**TOWNSHIP OF SOUTH WHITEHALL
LEHIGH COUNTY, PENNSYLVANIA**

**C. PROPOSED COMMERCIAL DEVELOPMENT 1810 PA ROUTE 309
MAJOR PLAN 2020-103**

TO: PLANNING COMMISSION
FROM: GREGG ADAMS, PLANNER
**SUBJECT: PROPOSED COMMERCIAL DEVELOPMENT 1810 PA ROUTE 309
MAJOR PLAN 2020-103
REQUEST FOR PRELIMINARY/FINAL PLAN REVIEW**
DATE: DECEMBER 13, 2021
**COPIES: BOARD OF COMMISSIONERS, R. COPE, D. MANHARDT, L. HARRIER,
D. TETTEMER, L. PEREIRA, ESQ., APPLICANT, SUB. FILE 2020-103**

RE: 1810 PA Rte 309 Convenience Store Land Development Plan
SWT Major Plan # 2020-103

UTILITY PLAN

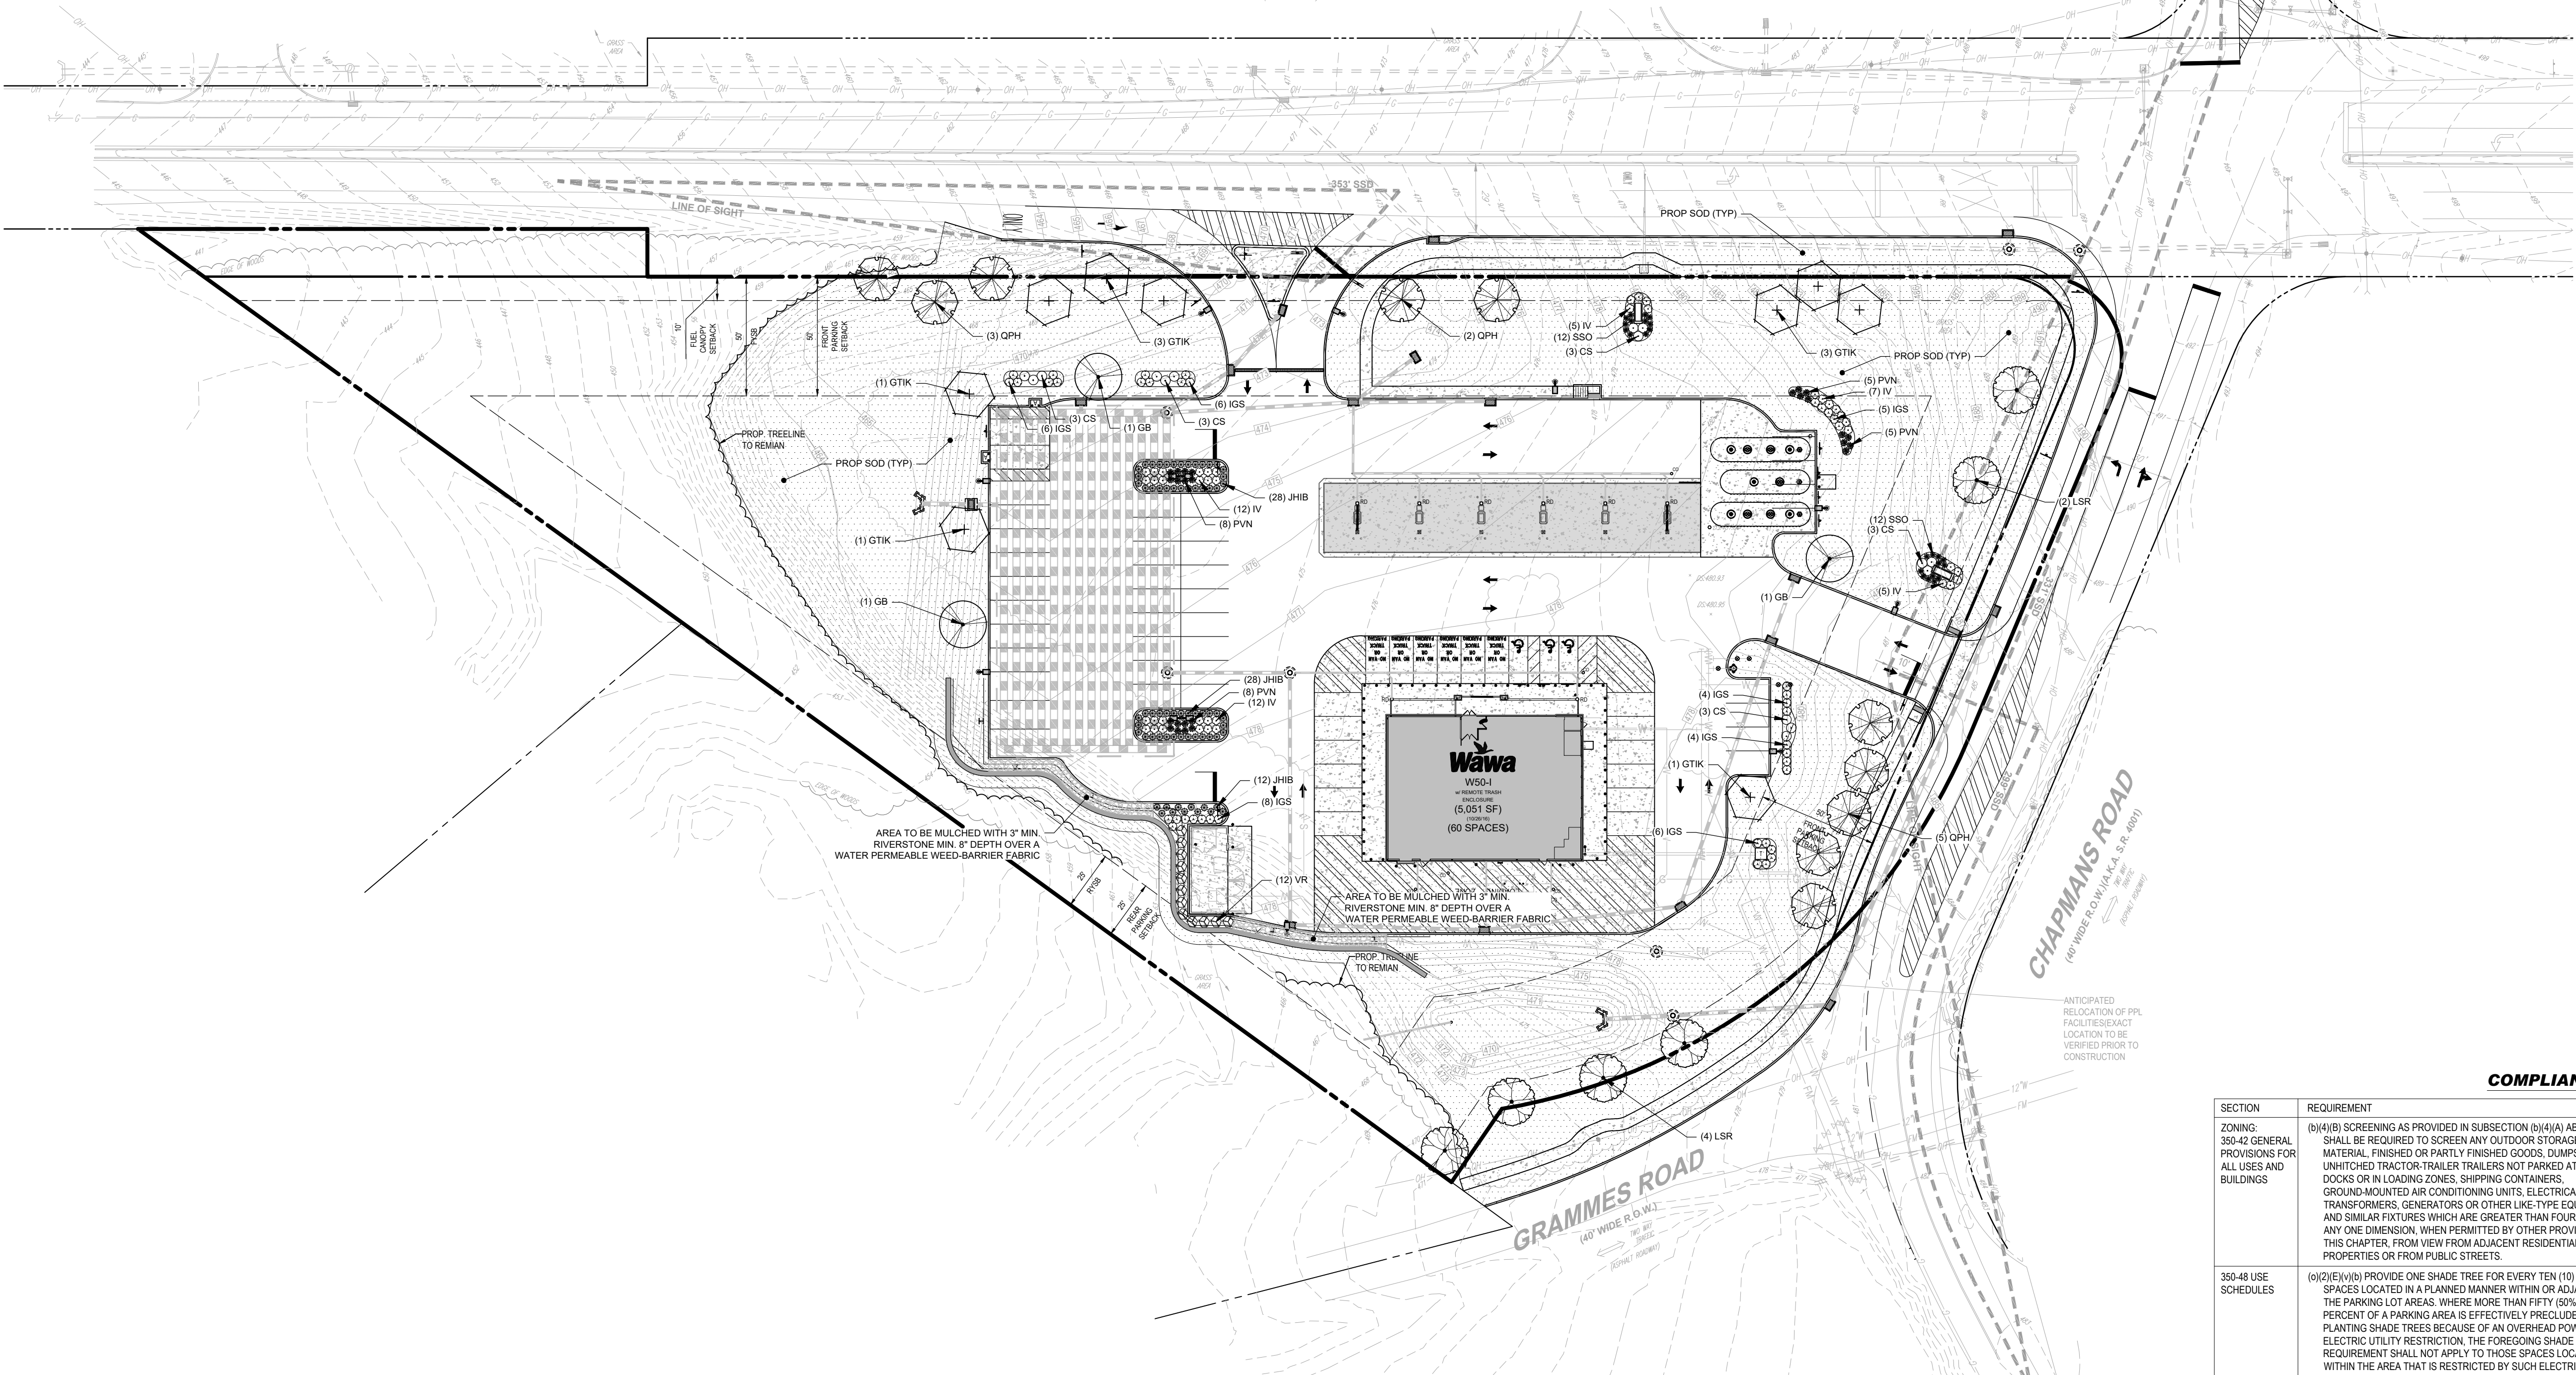
1. NOTES Sheet/Sheet Number C-102 Drainage and Utility Notes –General Water #33 not required on this plan.
2. Sheet Title Utility Plan/Sheet Number C-501
A. Water meter pit with Fire line and domestic water line is not required on this plan.
3. Sheet title: Details: Sheet number C-905: SWT Construction Standard SWT-W-7 not required on this plan.
4. Sheet Title Utility Plan/Sheet Number C-501
A. Domestic water line should not exceed 4” DIP size.

1. Please explain the water line connected to the garbage area.
2. Fire and domestic water lines should be placed with separate meters within the same meter pit.
3. All water lines will be owned by the developer from the tapping sleeve and valve to the building.
4. All Storm Water BMP maintenance and inspection records shall be submitted to the Township annually.
5. Please show downstream impact of storm sewer drainage.
